Levers Fed #1

Workover Non-AFE

Objective - Pull production tbg, ESP w/ cable, & capillary string. Set RBP above perfs. Circulate packer fluid.

Temporary Abandonment of Wells on Federal Lands Conditions of Approval

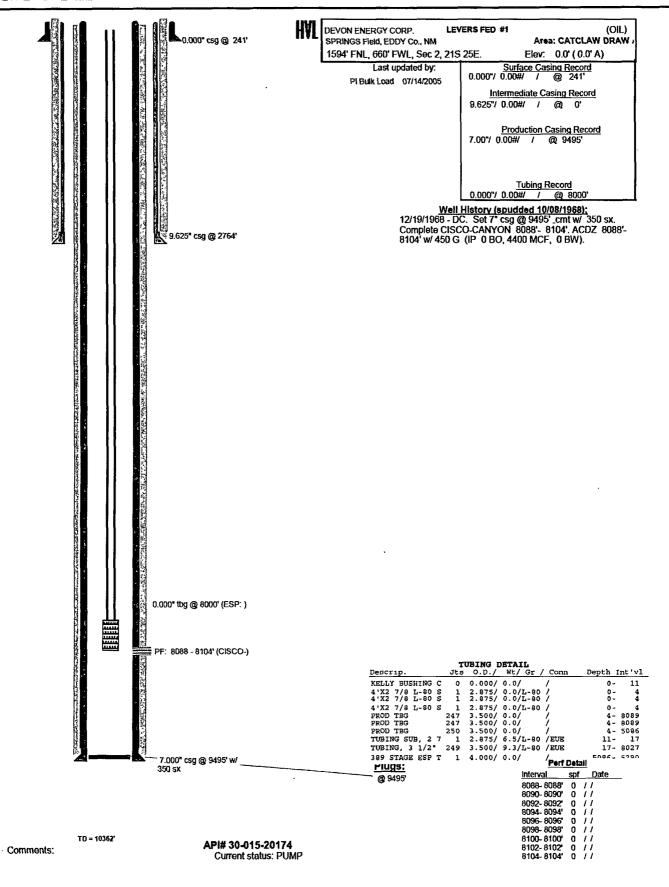
Levers Federal #1. Well may be approved to be TA/SI for a period of 90 days until December 3, 2010 after successful MIT and subsequent report with well bore diagram is submitted. This will be the only TA approval for this well. Well must be P&A or plans to return to beneficial use submitted by December 3, 2010.
